North Eastern Regional Power Committee

Agenda

Protection Sub-Group Meeting

Date : 04/05/2023 (Thursday)

2.8 Grid Disturbance at Kohima/Wokha area of Nagaland System on 20-04-23:

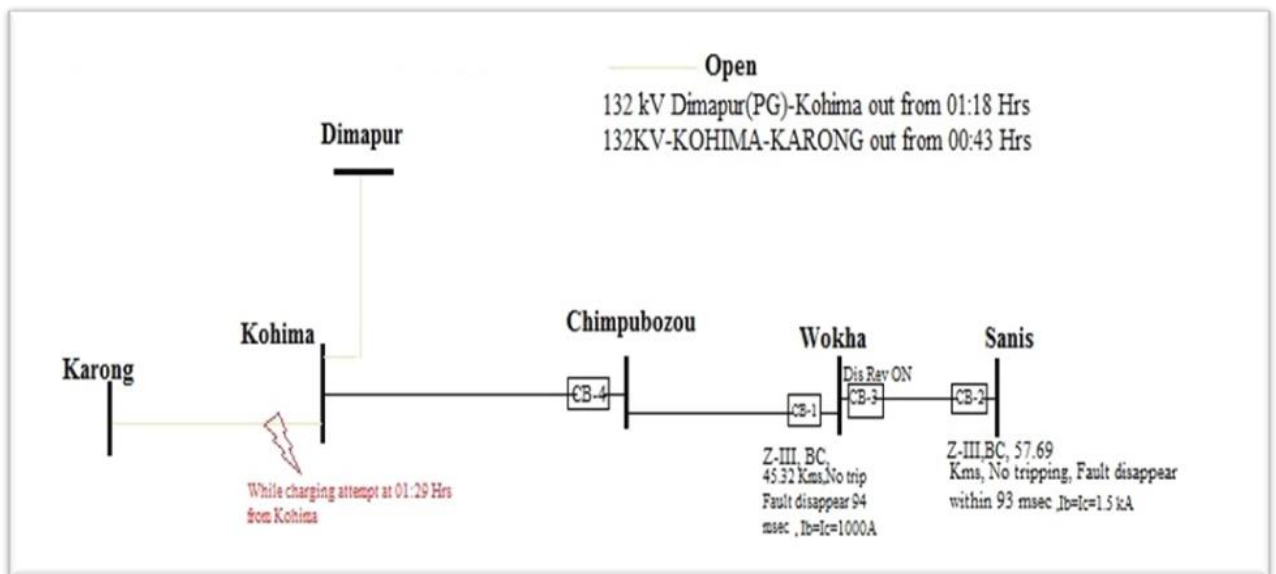
At 01:29 Hrs of 20-04-23, 132KV Sanis-Wokha & 132KV Wokha-Chiepebozou Line tripped while taking charging attempt in 132kV Karong-Kohima at Kohima, leading to blackout of 132 kV Kohima (Capital) area of Nagaland System.

1. Protection system at Kohima for 132 kV Karong Line fails to clear fault which led to detection of Z-III from Wokha & Sanis S/s.
2. Distance relay of Wokha (for Sanis line) detects Reverse zone, however tripped on Backup Overcurrent.

As fault in Reverse side, B/U relay should not trip at Wokha. B/U relay setting/directionality may be checked.

DoP, Nagaland is requested to intimate the root cause of the event and remedial measures that has been taken to prevent re-occurrence of the same.

2.10 Grid Disturbance at New Umtru area of Meghalaya System on 15-03-23:

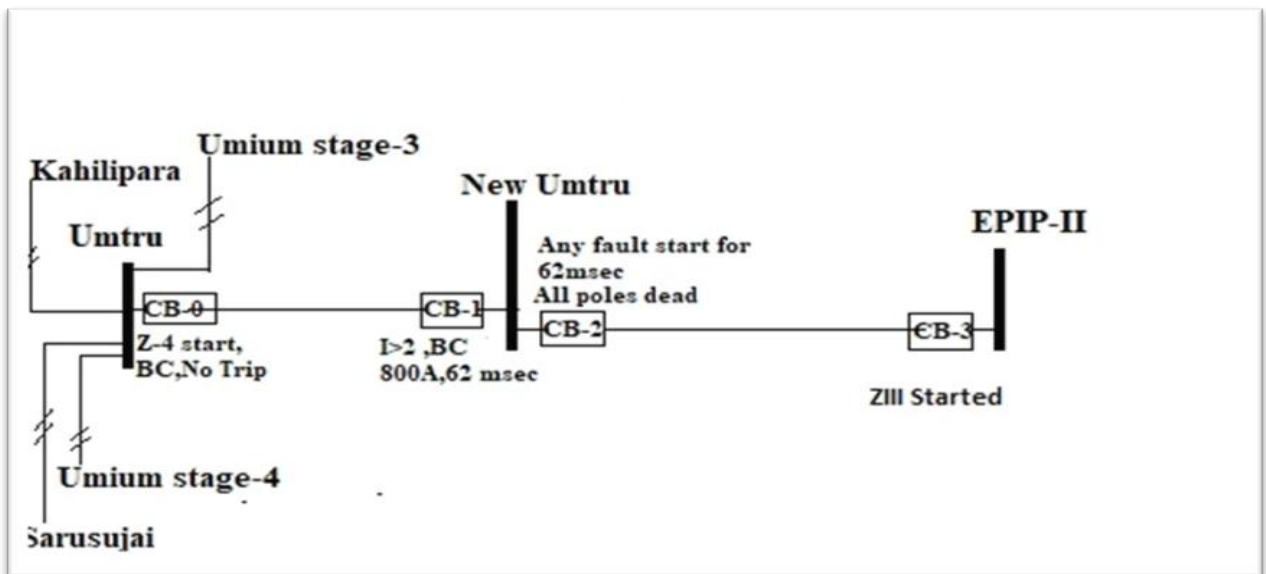
At 21:07 Hrs on 15/03/2023, 132 kV New Umtru – Umtru and 132 kV New Umtru- EPIP II line tripped resulting Grid disturbance of category GD-1 at New Umtru(Gen Loss :18 MW) area of Meghalaya system.

1. Ph to Ph fault was detected at Umtru in reverse direction of 132 kV Umtru -New Umtru Line and fault was cleared from New Umtru on I>2 within 62 msecs. I>2 setting needs to be checked/reviewed by MePGCL

2. Only ZIII Starts signal appears in the DR output of EPIP end for 132 kV New Umtru line. Which protection issued the trip signal after 700 msec need to be check and proper action may be taken by MePTCL.

2.11 Tripping of 132 kV Umium Stage-1- Umium Line along with 132 kV Mawphlang - Umiam Stg I D/C Line and 132 kV Mawlai - Umiam Stage I Line at 10:23 Hrs of 24/4/23 :

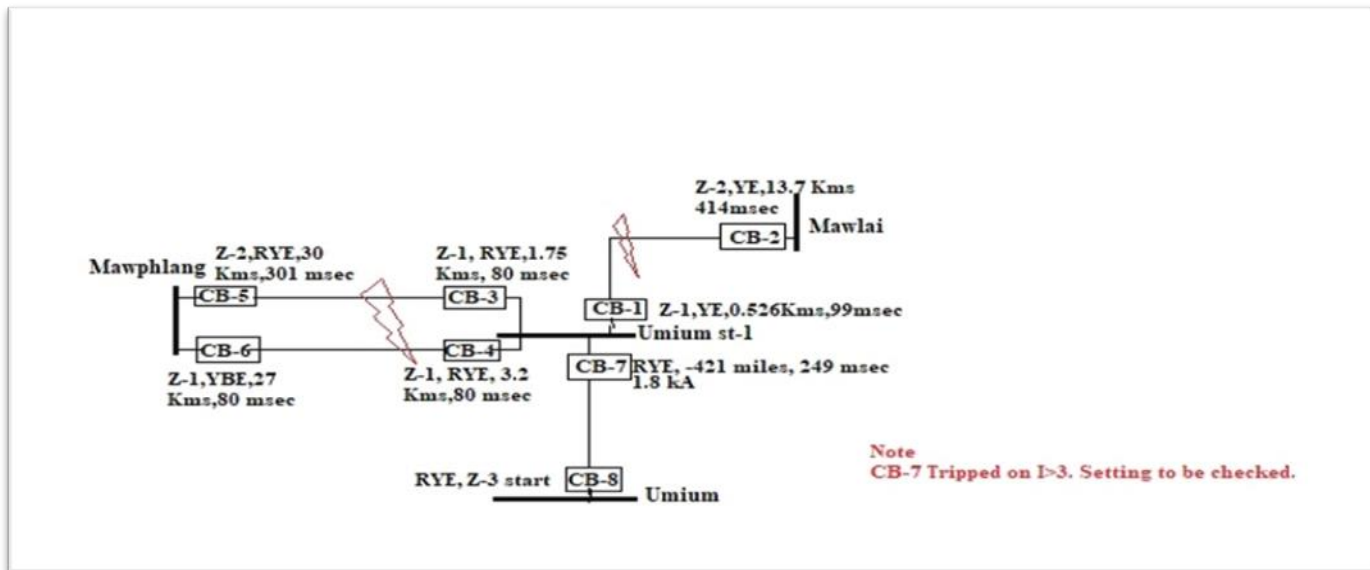
As per DR Analysis, Double phase to earth fault was in 132 kV Mawphlang - Umiam Stg I D/C Line and 132 kV Mawlai - Umiam Stage I Line at 10:23 Hrs of 24/4/23 and faults cleared from Umium stage-1 within 99 msec on Z-1 operation. At the same time, healthy 132 kV Umium Line tripped only from Umium stage-1 on I>3 (Ib:1.8 kA).

1. There was no fault on 132 kV Umium Stage-1 to Umium Line as only Z-III, RY-E detection was recorded from Umium end DR data. The directionality of backup relay (CT inputs to the relay after star point towards line side) and setting from Umium stag-1 end needs to be checked/reviewed at earliest to prevent further tripping of healthy line.
2. Time drift of about 1 hrs observed in all DR/EL data from Umium stage-1/Mawphlang/Mawlai/Umium which needs to be time sync with GPS in line with various CERC/CEA regulation to get the actual

Therefore, MePTCL/MePGCL is requested to intimate the root cause and remedial measures taken.

2.22 Review of SPS at Monarchak:

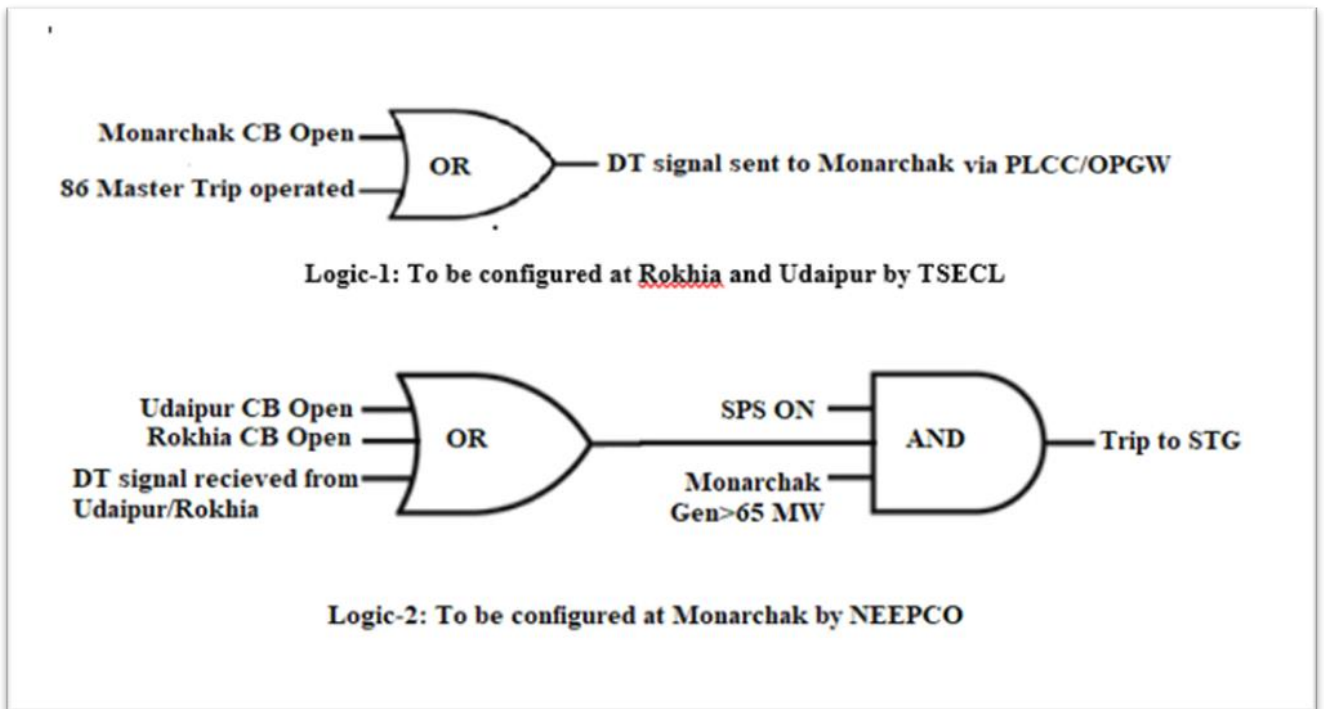
At 01:11 Hrs dtd 31/3/23, 132 kV Monarchak-Udaipur Line reclosed successfully from both ends and SPS@ Monarchak operated which led to tripping of STG Unit.

1. 1 ϕ -Distance Trip inputs to SPS is not required as already we have CB open inputs. This will prevent SPS operation in case of Auto-reclose successful at both ends.

2. Following two events needs to be taken care for smooth functioning of SPS:

- a) Any one CB of either 132 kV Udaipur and Rokhia tripped at Monarchak Station and Gen>65 MW
- b) A/R successful at Monarchak but CB tripped at Rokhia/Udaipur and Gen>65 MW

To achieve above sl.No.2 the following new revised scheme proposed for review and further implementation.
